# CITY PLANNING COMMISSION

- APPLICATION:**
- A. Negative Declaration
  - B. Rezone 47+ acres from Agricultural (A) to Single Family (R-1) (Sec. 13)
  - C. Tentative Map (P84-229)
  - D. Subdivision Modification to create lots in excess of 160 feet deep. (Ch. 40.322(c))

**PROPOSAL:** The applicant is requesting the necessary entitlements to subdivide 47+ vacant acres into 166 single family lots.

TENTATIVE MAP

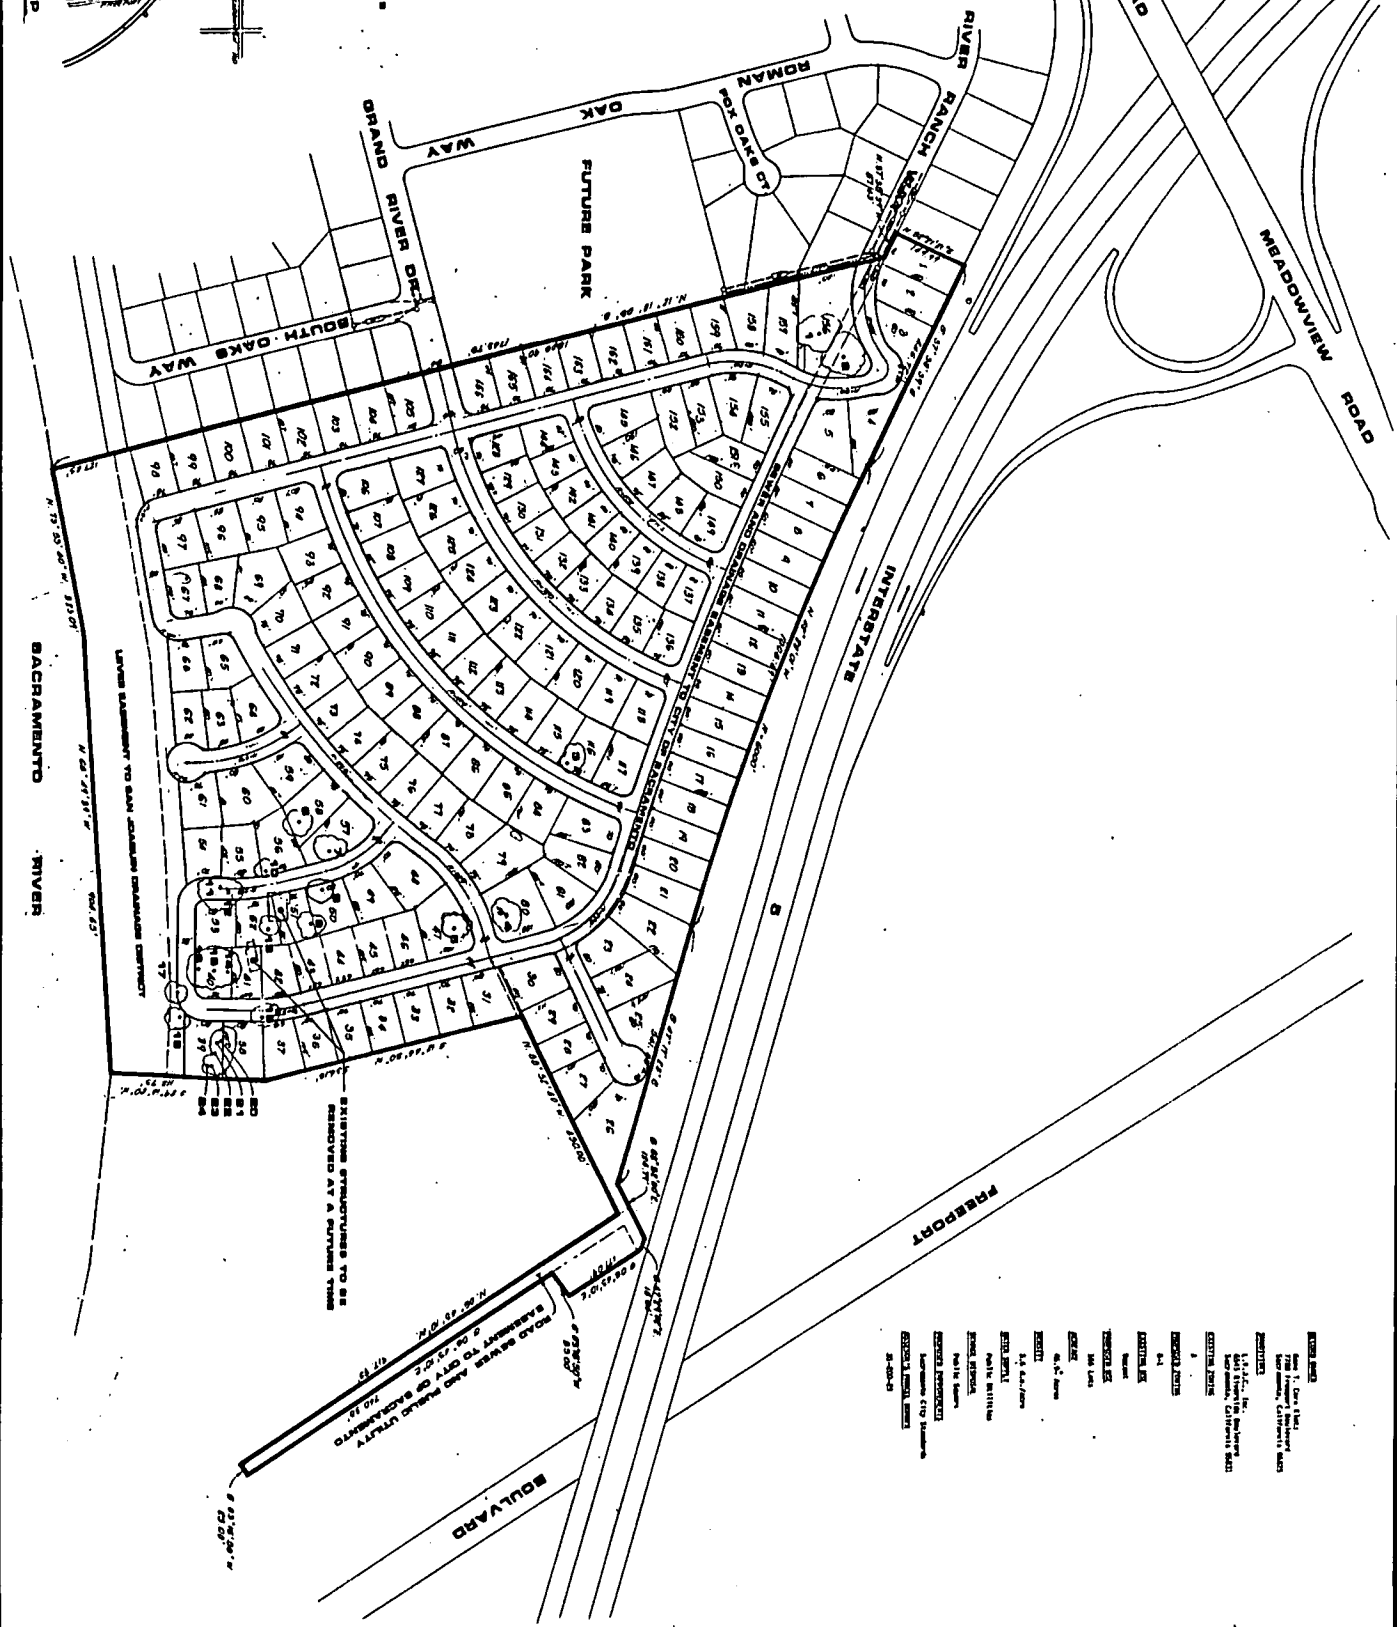
- B. The street design is dictated by the existing subdivision to the west, proximity to the freeway and Sacramento River and a number of trees on site. Staff and the Subdivision Review Committee, therefore, support the request to create lots in excess of 160 feet in depth. Lot 26 should be reserved for single family development.
- C. The applicant indicates a levee easement to be dedicated to the San Joaquin Drainage District on the tentative map. This strip should be designated Lot A on the final map. For consistency with the Sacramento River Parkway Plan, Lot A is to be dedicated to the City.
- D. A long, irregularly shaped strip of the subject site extends south from I-5. This is a road, sewer and public easement which should be designated Lot B and dedicated to the City for access to the sewer treatment plant.

- F. The Planning and Community Services Divisions have determined that dedication of 2.473 acres of land is appropriate for parkland purposes. In order to provide additional street frontage for the existing park adjacent to the east and save the large trees on Lot 156. Community Services Division is requesting dedication of lots 156 through 166. The applicant will be responsible for a nominal amount of additional fees to equal 2.473 acres.

- H. The site is impacted by freeway noise from I-5. The applicant has submitted an accoustical report which has been approved by the County Health Department. In order to mitigate the noise problem, the accoustical engineer recommends a solid wall be erected along the rear lot lines of lots one through 22. This shall be done prior to final map recordation.

10. Remove structures on Lots 41 and 51;
11. Provide a 20-foot sewer main easement between Lots 30 and 31;
12. Dedicate a 10-foot wide maintenance easement from the landward toe of the levee to the State Reclamation Board;

13. Designate levee easement as Lot A on map and dedicate Lot A to the City for Sacramento River Parkway purposes;
14. Designate road, sewer and public utility easement as Lot B and dedicate it to the City;
